Public Service
Company of Colorado

April 14, 1986
Fort St. Vrain
Unit No. 1
P-86293

SUBJECT: Radiological Alarm in
Platteville, Colorado

**SUPPLEMENT TO
MODEL EOWS*
INSTALLATION AND SERVICE INSTRUCTIONS**

Control Unit Wiring Diagram.

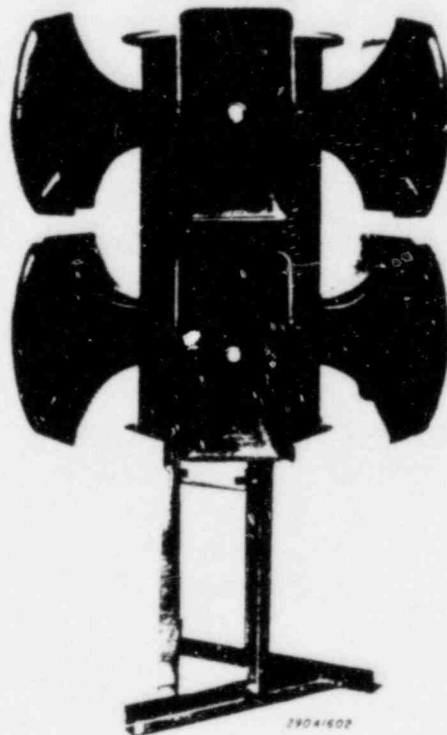
A. The EOWS rotator circuit has been changed to provide a greater range of available current for extremely cold weather. Disregard figures 4-3 and 7-1 in the Installation and Service Instructions and use the Control Unit wiring diagram included in this supplement. The changes that are reflected in the new diagram are:

1. The rotator fuse and fuseholder have been deleted.
2. The battery wire (+) that went to the fuseholder is now connected to the rotator relay socket, pin 8.
3. Pins 1 and 8 are jumpered together.
4. Pins 4 and 6 are not jumpered.
5. Pins 3 and 6 are jumpered together.
6. The 70-ampere main fuse (across battery) has been replaced with a 100-ampere.

Figure 7-1. Control Unit Wiring Diagram.

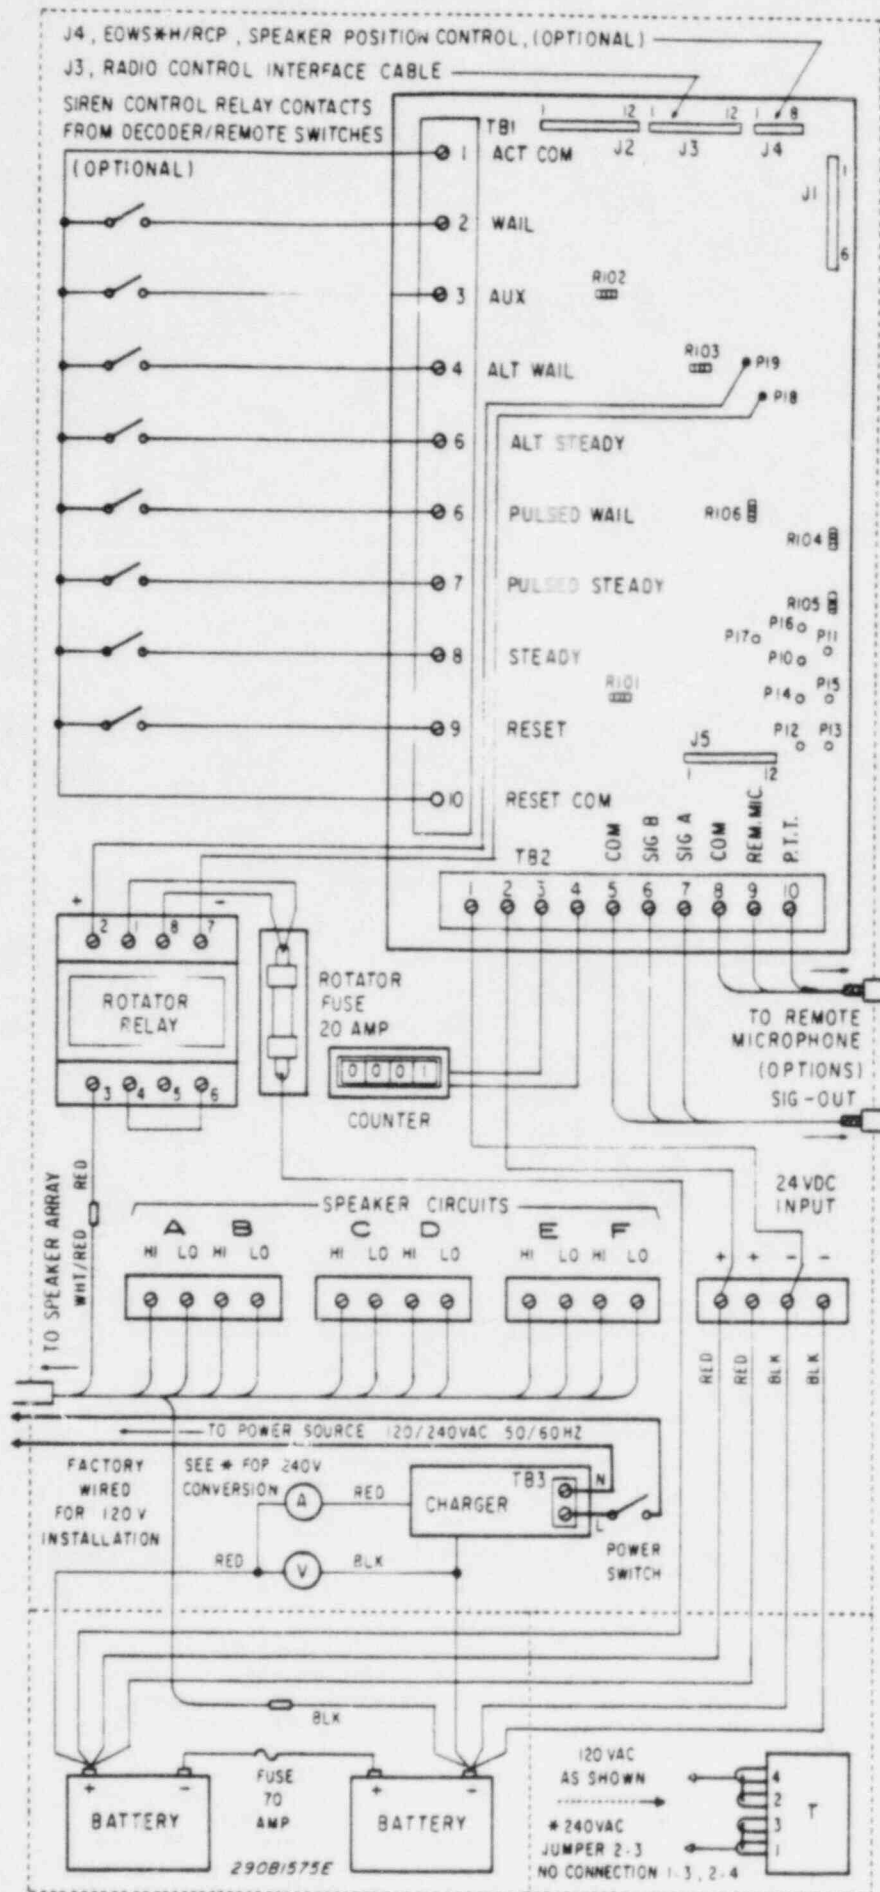
B. The following changes should be made to the diagram and parts list on pages 7-4 and 7-5.

1. The value of the item 11 fuse should be changed to 100 amp., JN100A (part no. 148A140A).
2. Delete fuseholder, item 36.
3. Add: Desiccant, part no. 288A339A, qty. 2.
4. Add: Vapor Capsule, part no. 288A340A, qty. 1.
